# City of Tualatin

## PARTITION REVIEW FINDINGS AND DECISION FOR PAR 16-0001, BURCHILL

SHEET  
**F300**  
JOB NO.  
2312-020

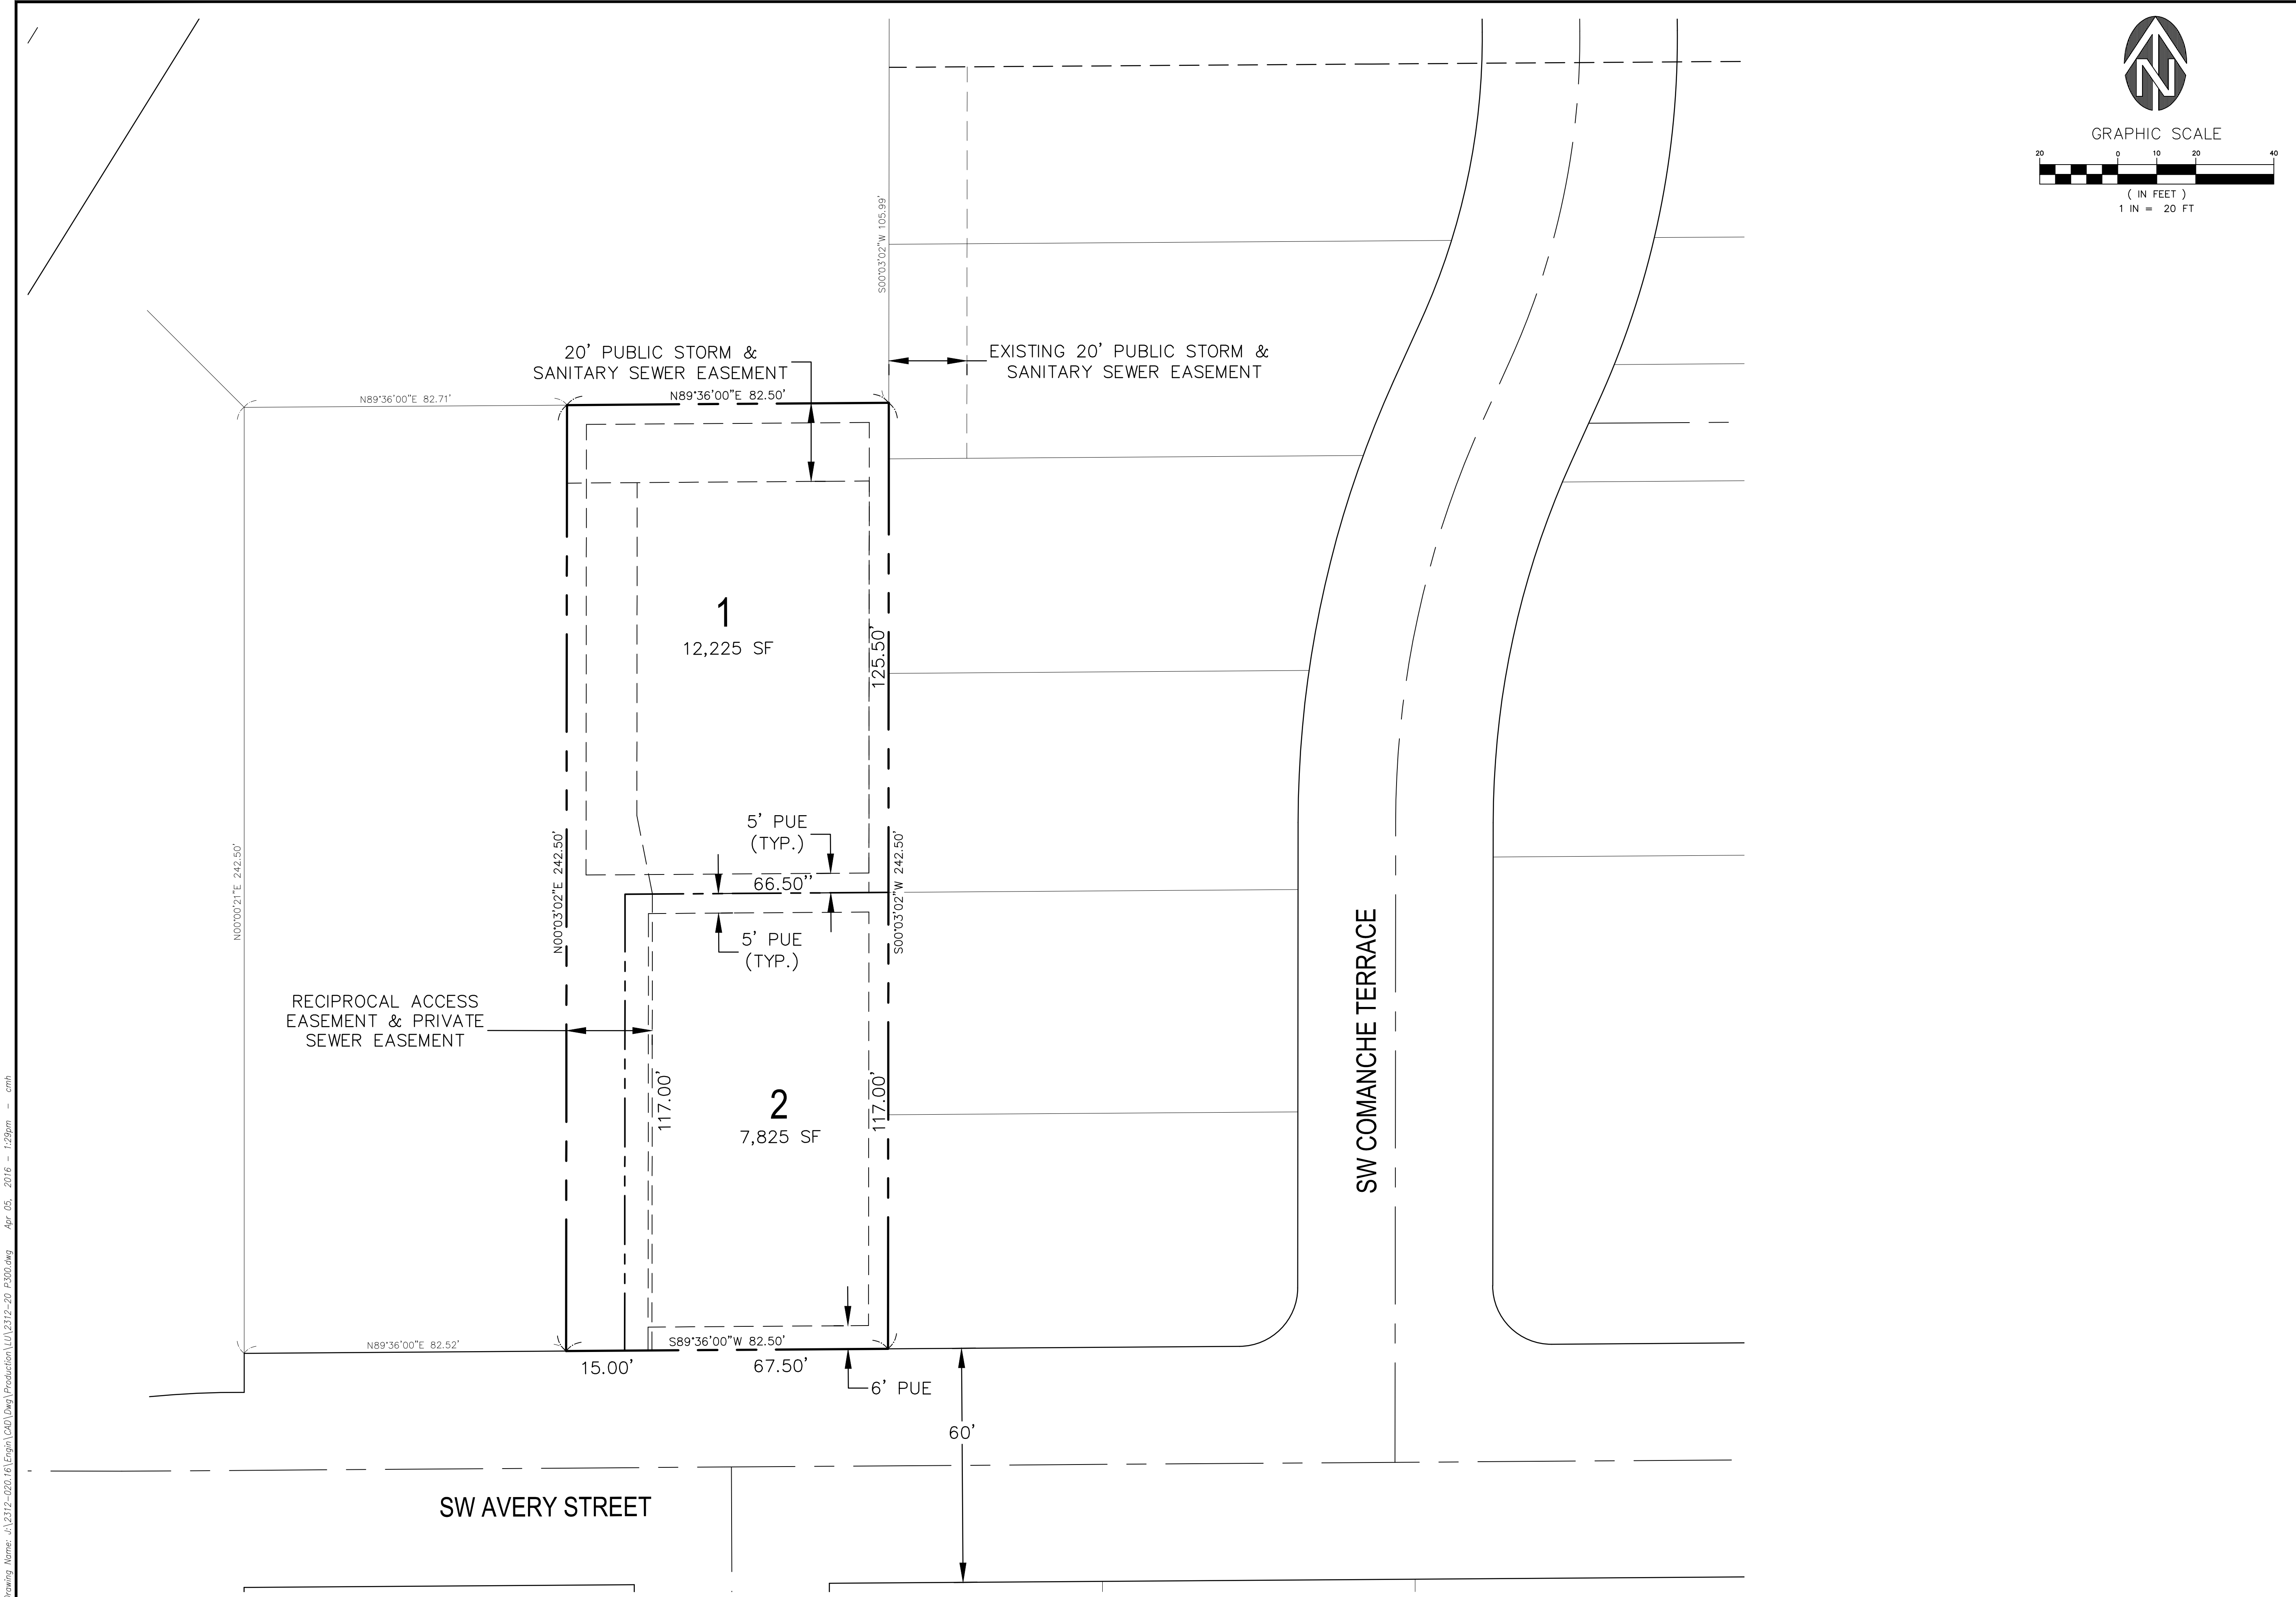
Staff notes that subsection (1) is met, and that Lot 2 is 66.5' in width, not 62.5', on its northern boundary per the preliminary plat plan, sheet P300, which still meets the requirement of subsection (2) and (3). Subsection (4) will be reviewed for compliance when a future Architectural Review –Single Family is submitted for single family homes on Lots 1 and 2. Staff also notes that the flag lot width of Lot 1 at the street is 15', not 20'. The applicant is conditioned to meet the requirement of Subsection (5).

SHEET  
**P400**  
JOB NO.  
2312-020

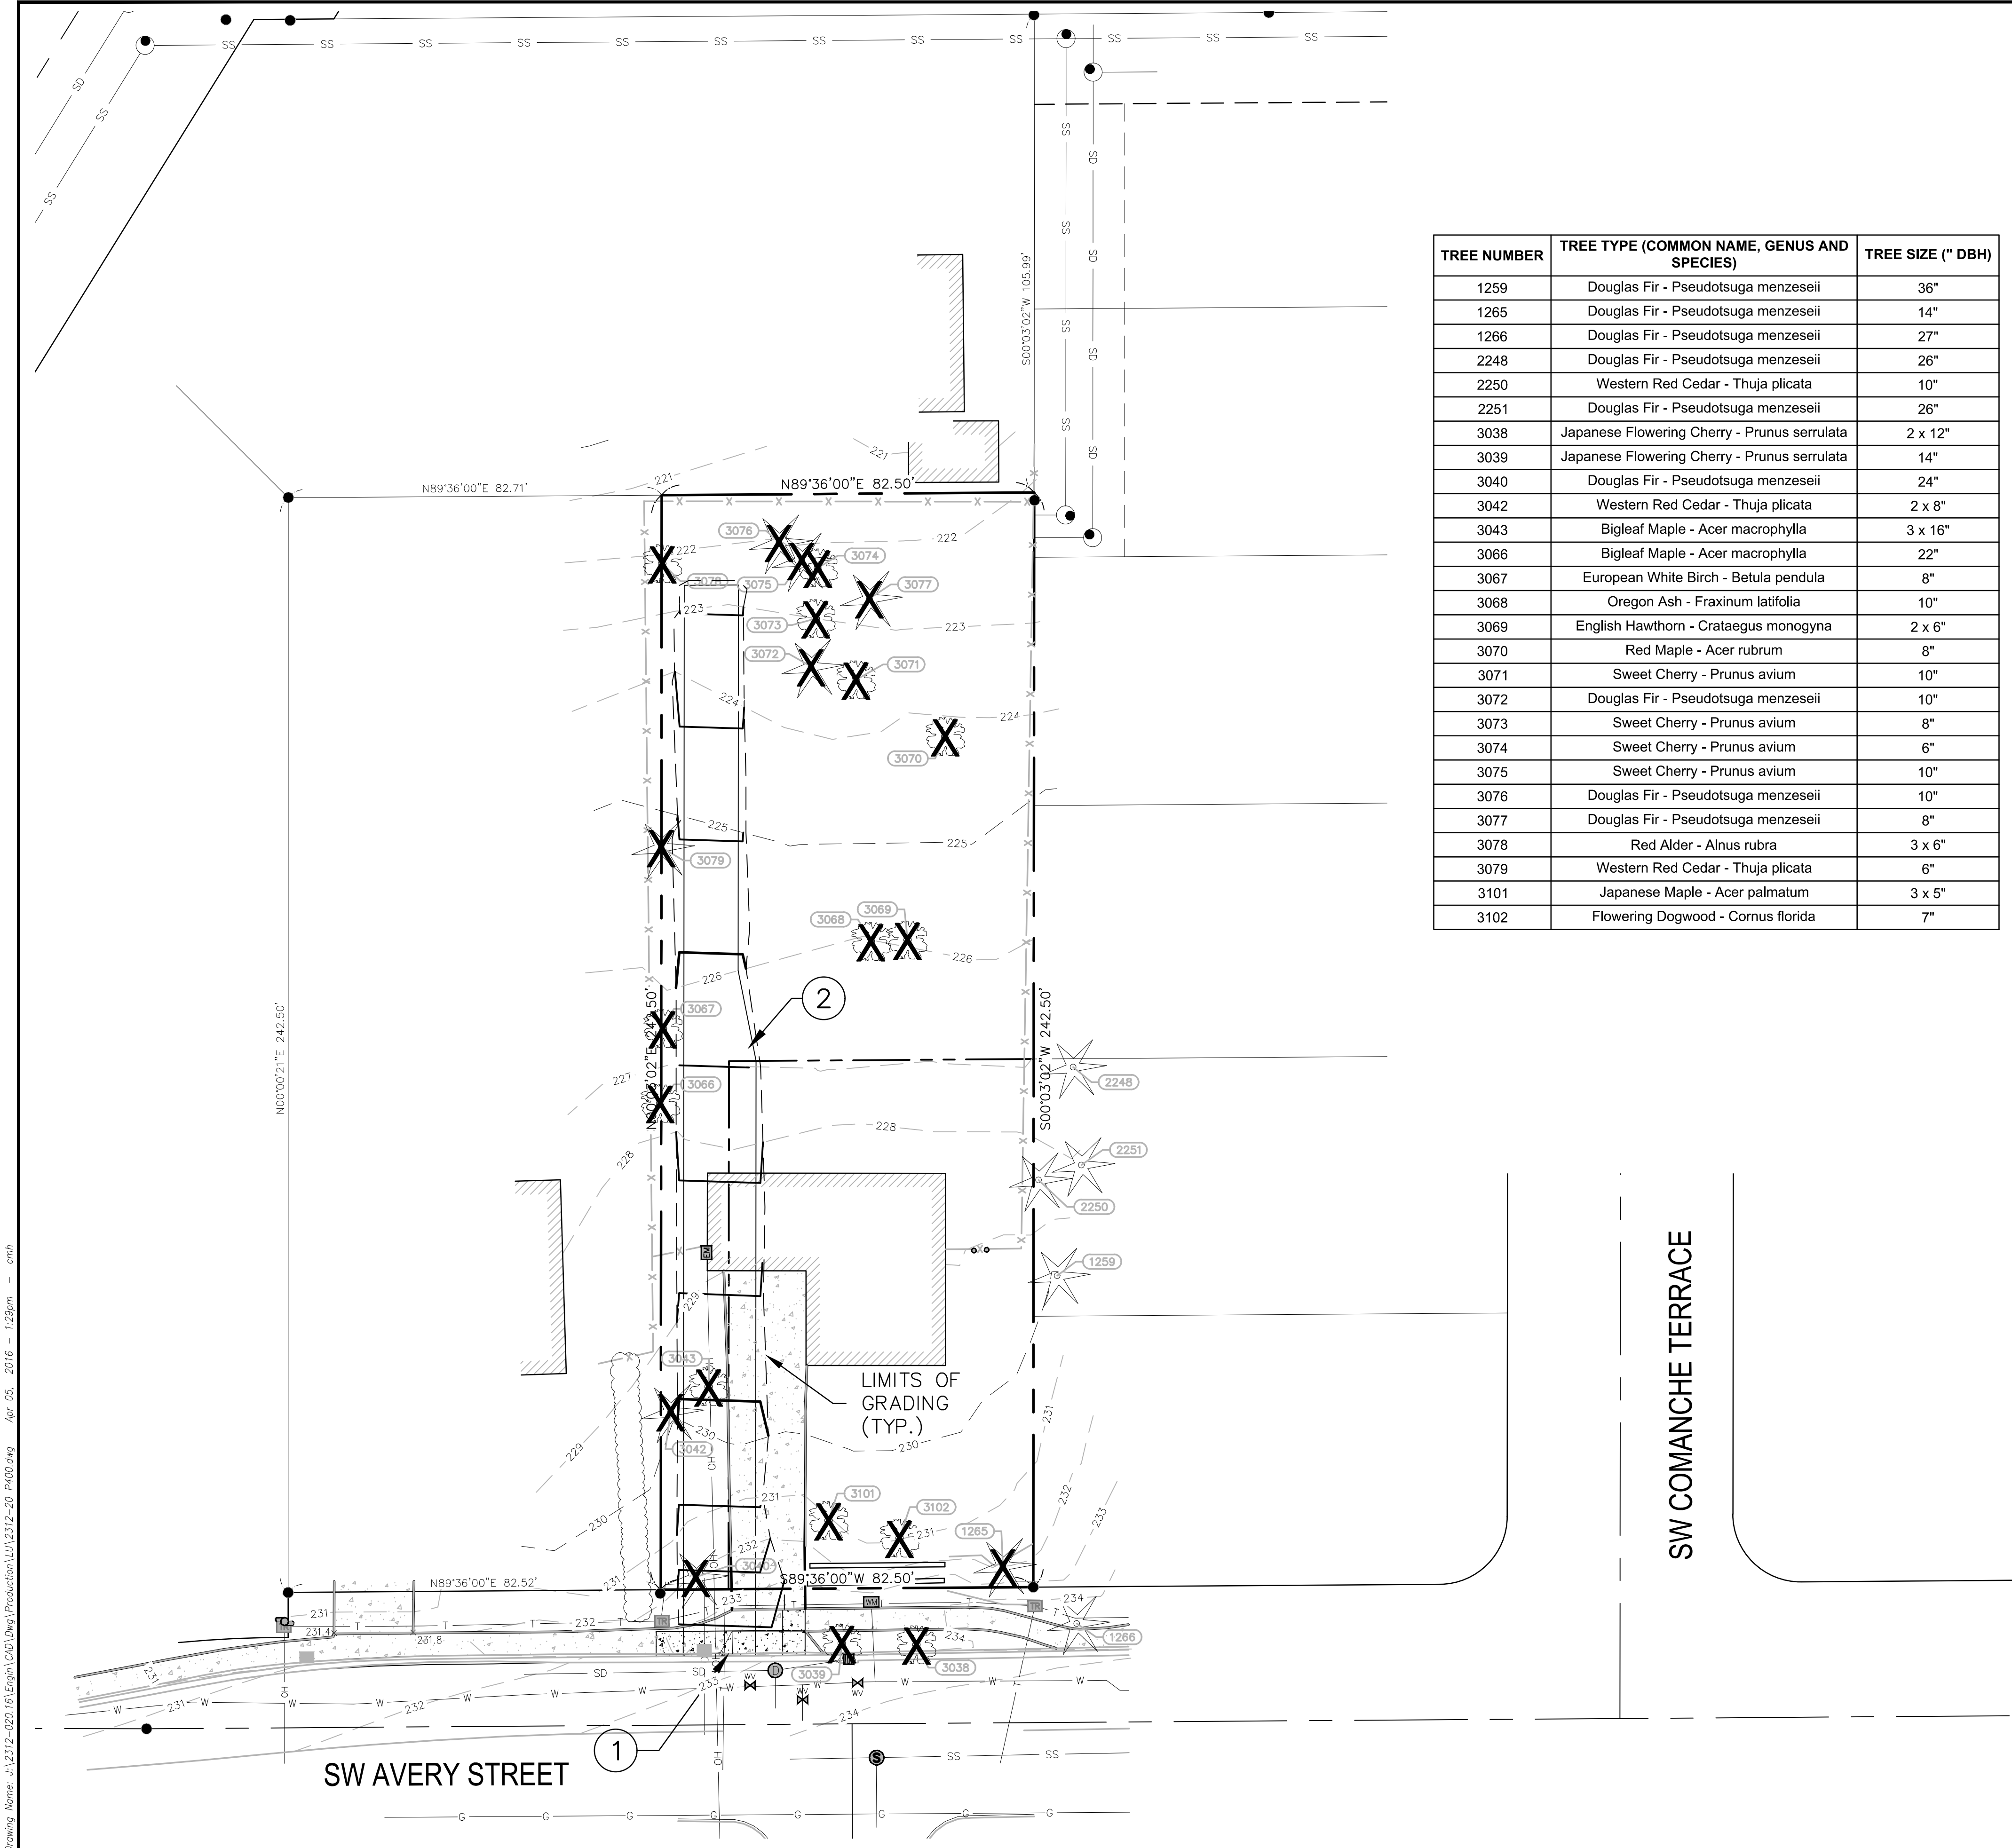
Staff notes a tree plan was submitted as Sheet P400, A CWS provider letter was submitted as Exhibit E, and an arborist's report written by Applied Horticultural Consulting, Inc. was submitted as Exhibit J. CWS has not requested special indications on the tree plan. Trees are numbered and illustrated, as required on the tree plan. There are 27 trees noted on site and 22 trees are slated for removal as described in both the tree plan and arborist report.

Staff notes that trees designated for retention are located on a neighboring property to the east (Mission Terrace Subdivision) as shown on the preliminary grading & tree plan, Sheet P400. These trees may have been impacted by development activities corresponding to the Mission Terrace Subdivision.

Staff notes a tree plan (Sheet P400) and Arborist report (Exhibit J) were submitted that identify the locations of all trees on site. Trees proposed for removal are necessary to construct the proposed improvements associated with the partition and have also been identified. Trees identified for retention are located on a neighboring property to the east (Mission Terrace Subdivision). As no trees are proposed for retention on the subject site, this requirement has been met.
